Addendum #2

Project Name: Concordia STEM
Seward, NE
Project No.: 16022-05
Date Issued: May 8, 2018
Bid Date: Thursday, May 17, 2018

MAIN LEVEL INSTALLATION LAYOUT FOR MOHAWK LICHEN COLLECTION

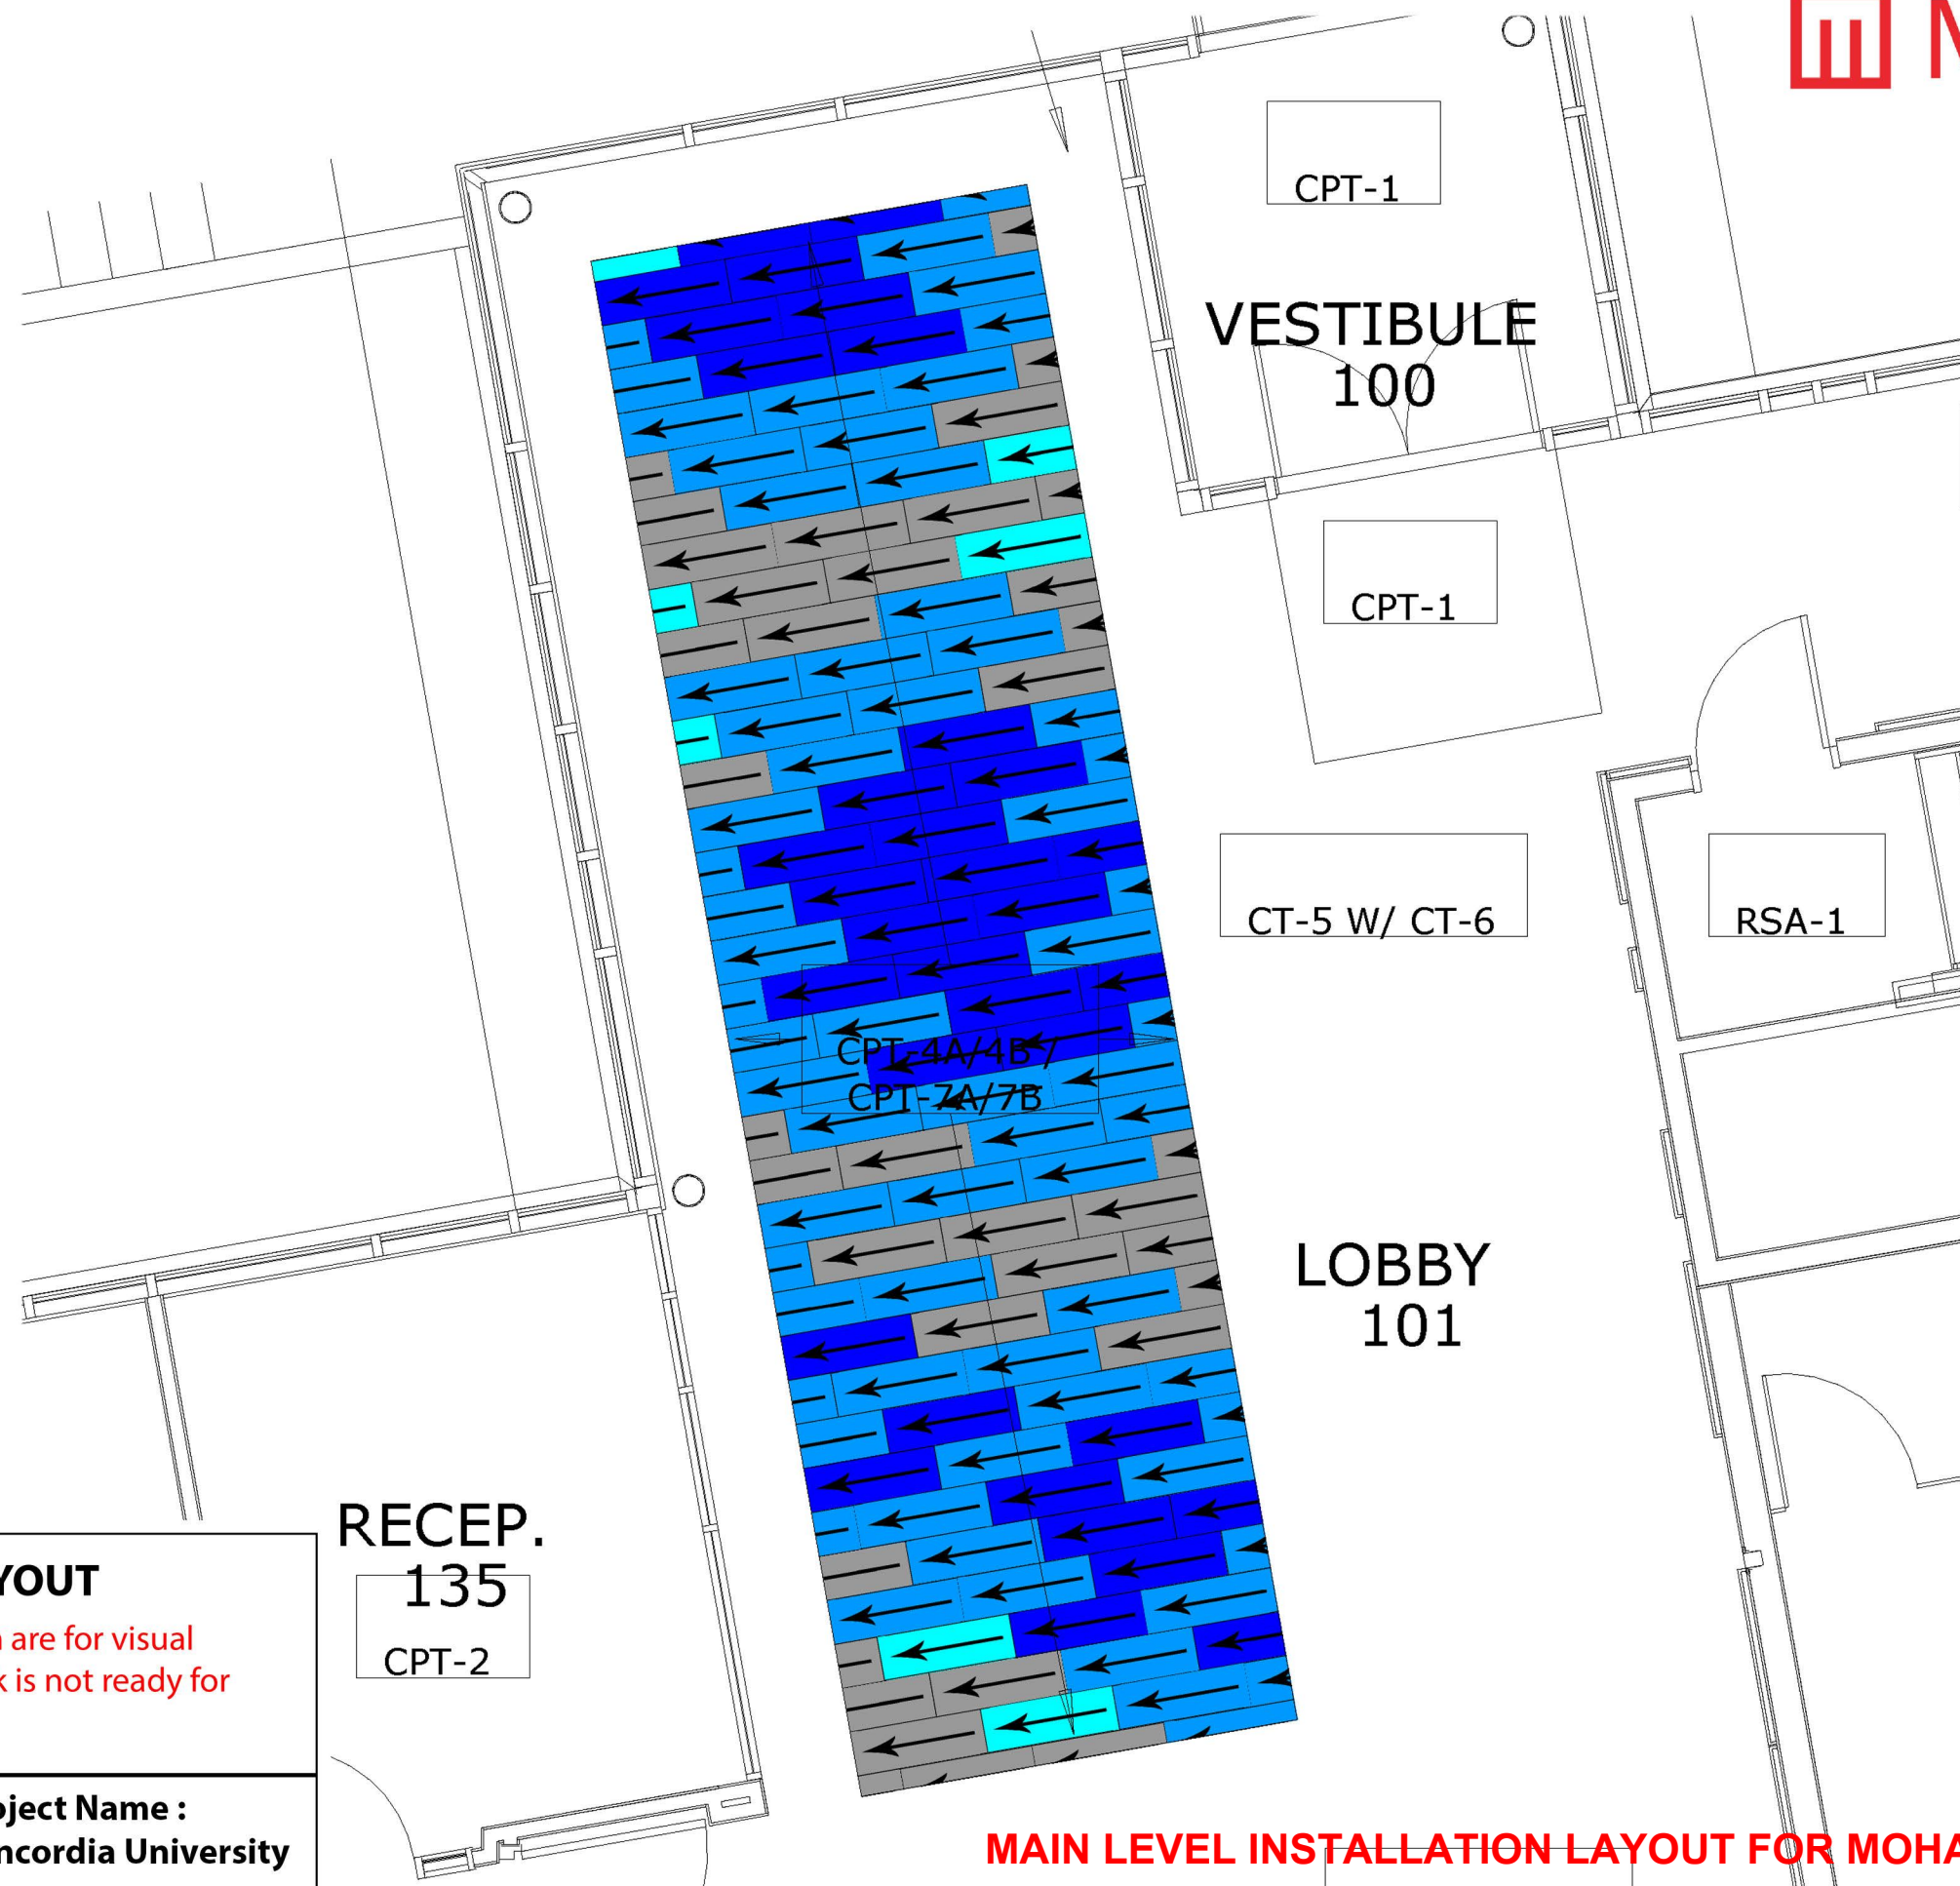
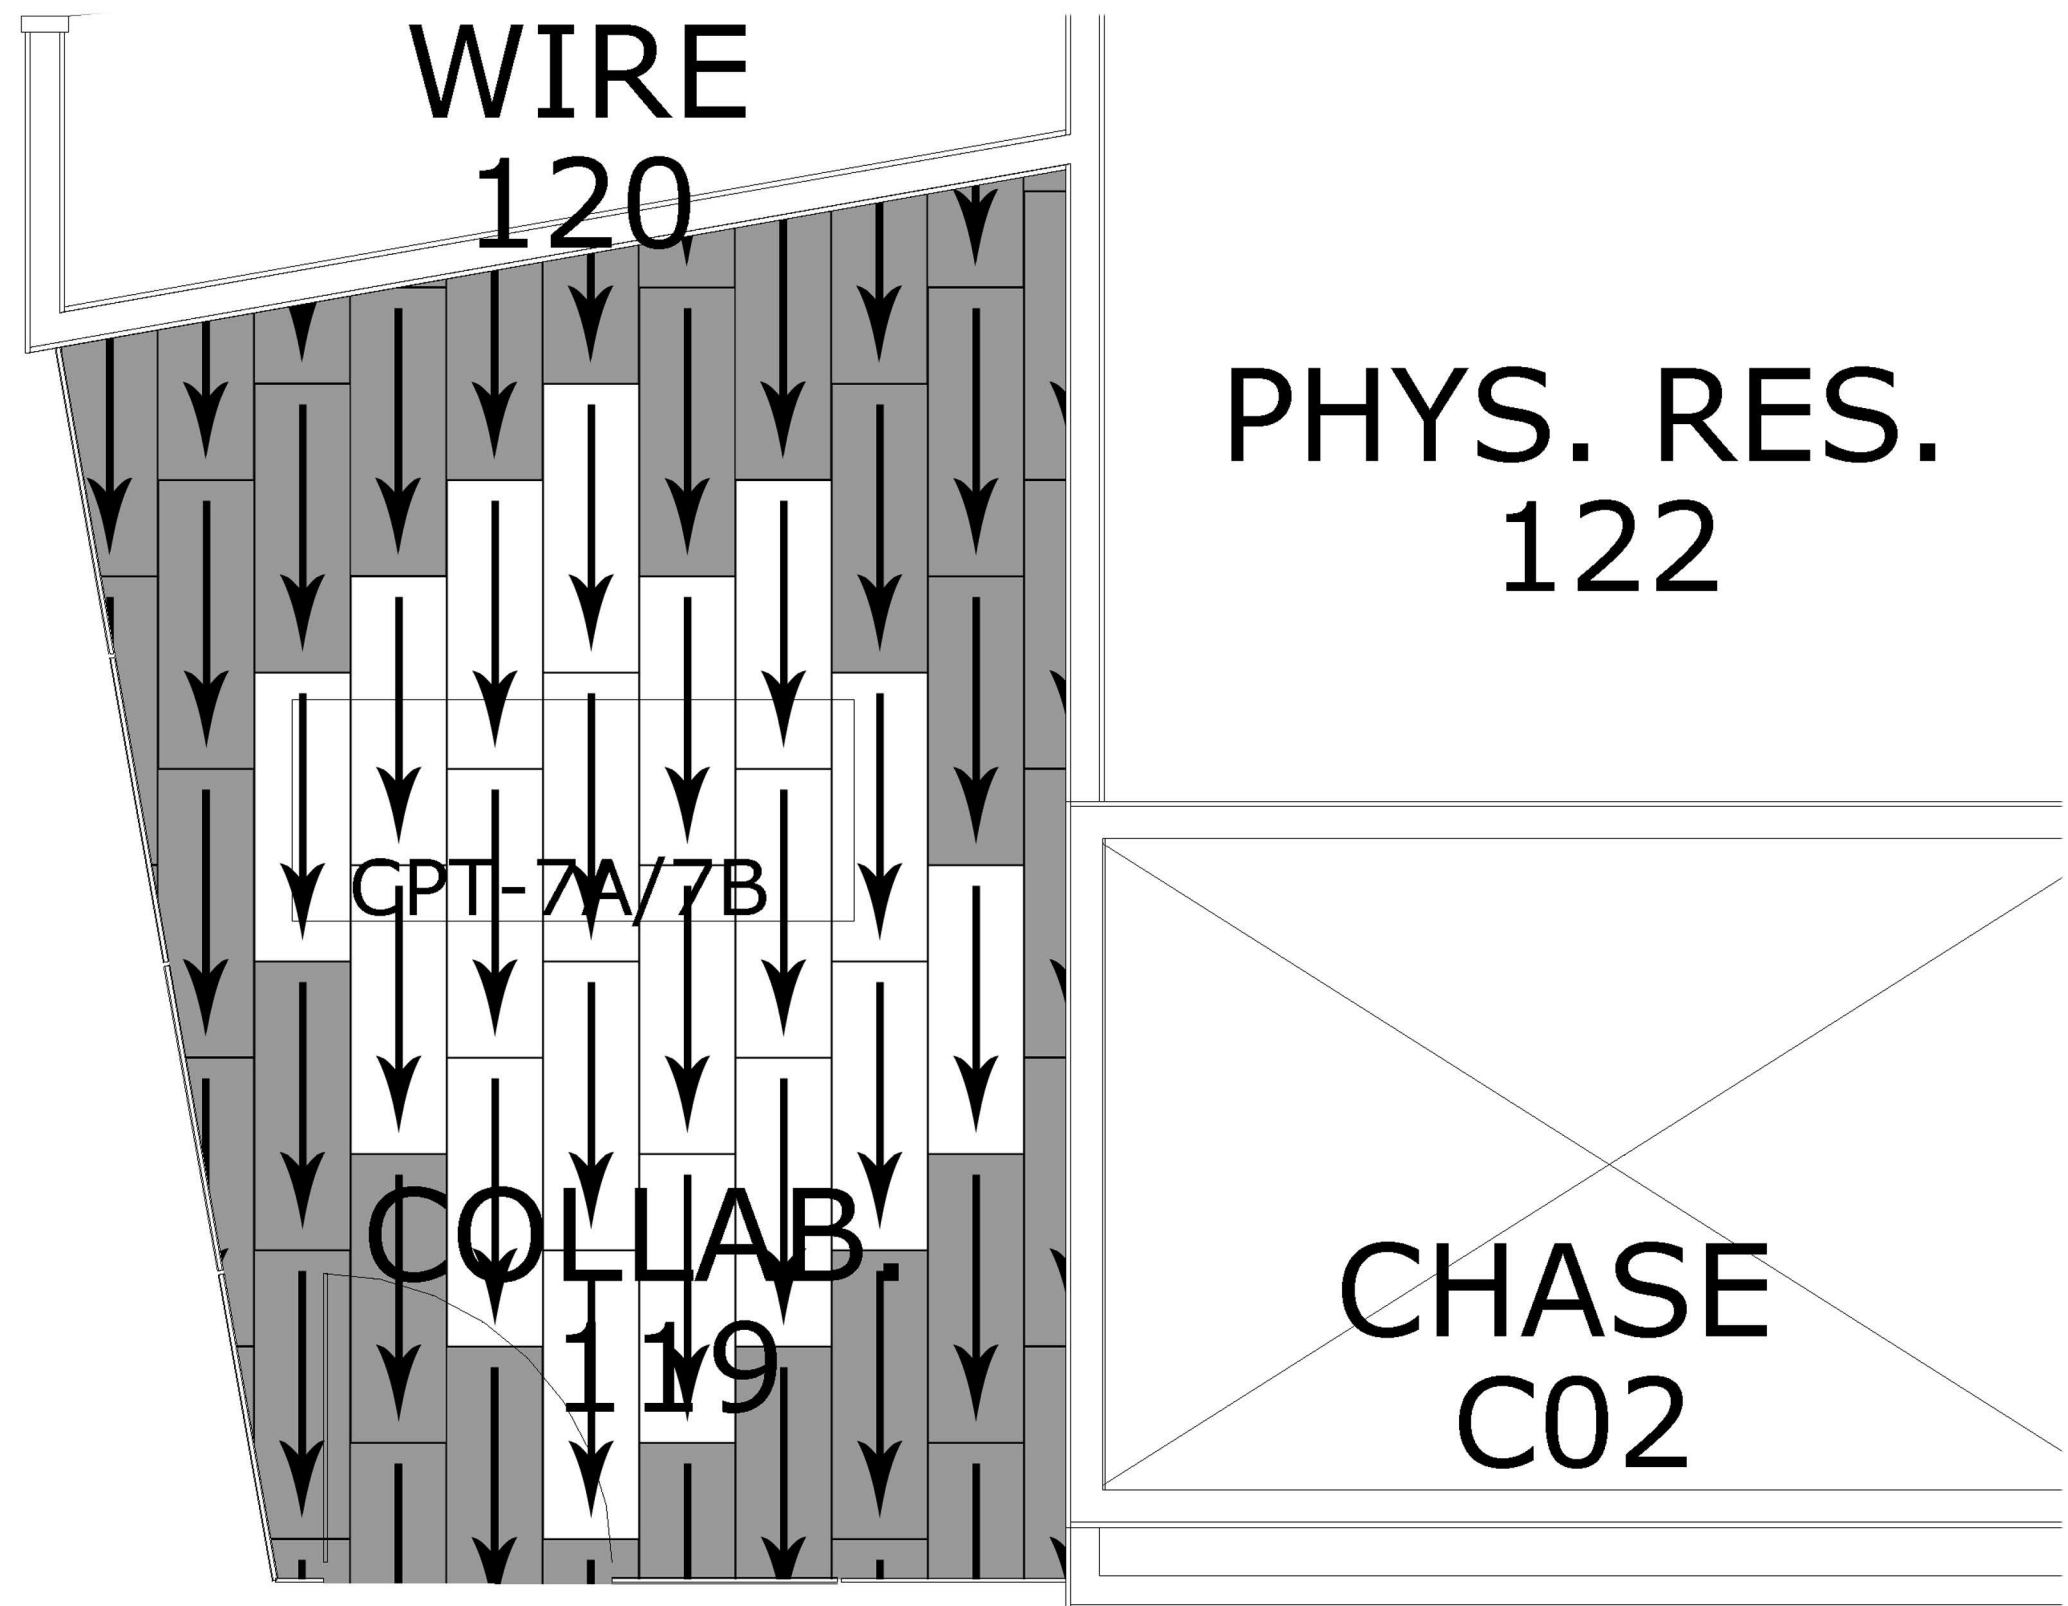
Question: *The areas of patterned carpet reference Note 4 on the plans, stating to see the manufacturer's layout included in specifications. Where is this layout with the specifications? We cannot find it for reference.*

Response: The attachments have been added to this addendum and are identified as 096813-A "Tile Carpeting Lichen Installation Layouts"
